CERTIFICATE OF APPROPRIATENESS

RE: Application Number 21-7155; 4100 Third, Willis-Selden Historic District

Vecino Restaurant 4100 Third Avenue Detroit, Michigan 48201

MECHANICAL EQUIPMENT SCREEN DETAILS "DRI-DESIGN, PERFORATED PANEL SERIES"
ORIGINAL IMAGE SCALE: 3" = 1'-0"

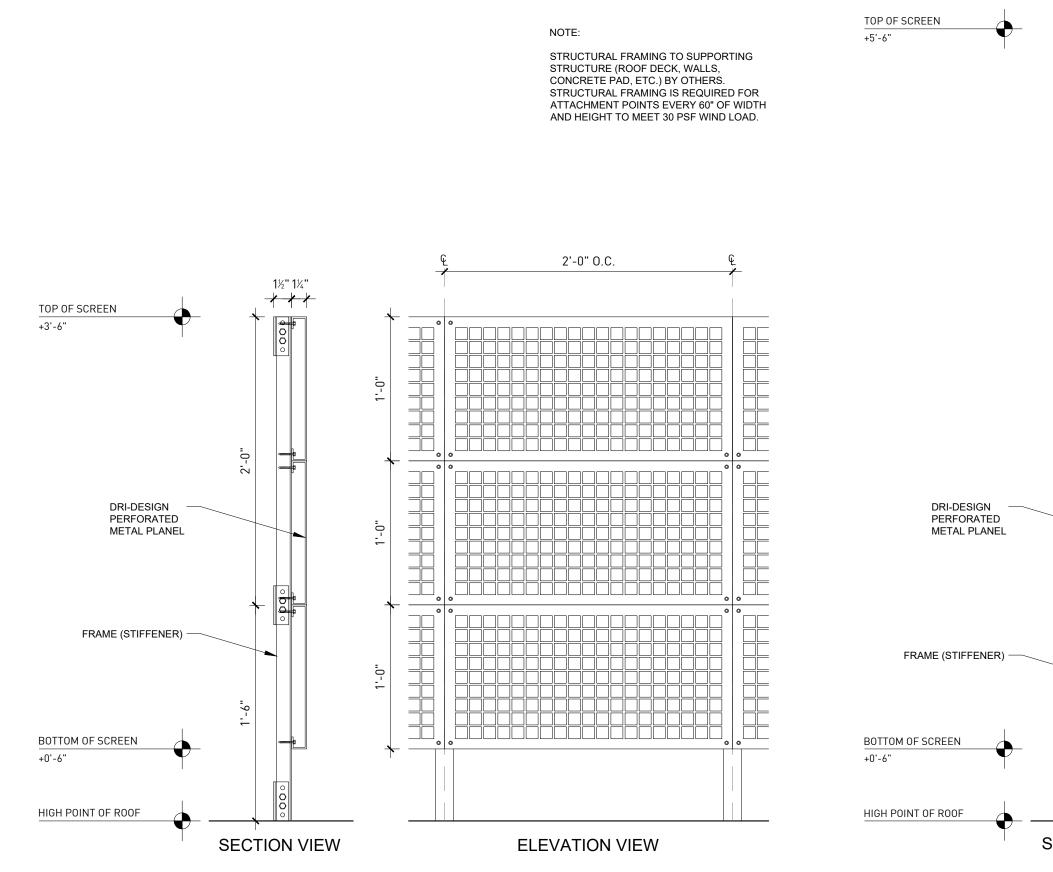
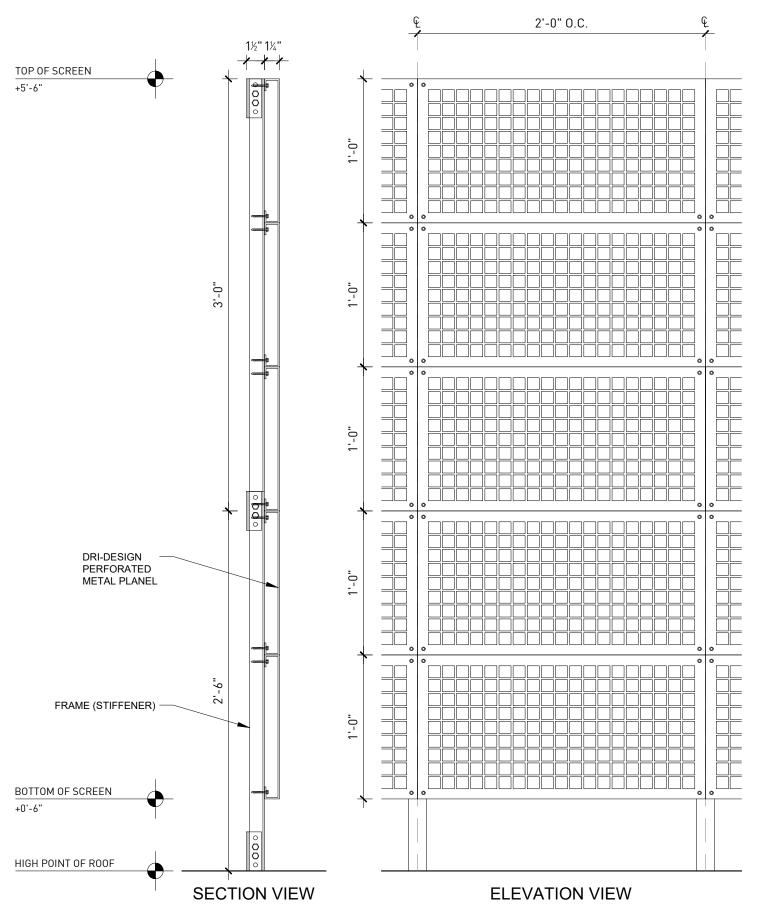
- Gates will be faced with Hardi Panel vertical siding, smooth finish, color: Iron Gray (similar to black)
- Install new mechanical equipment, supported by a new structural platform. Equipment will be enclosed with a decorative screen height is 3'-6" at northern end and steps up to 5'-6" at southern end.

- o Perforated panel screen, SQA by Dri-Design, color: vintage
- A metal ladder will be affixed to the north elevation to access the equipment, color: black.

- The lighting for the wall sign on the south elevation will be backlit.
- The material for the rooftop equipment enclosure will have a matte finish, if possible.
- The material and finish of the hanger for the entry sign will be noted.
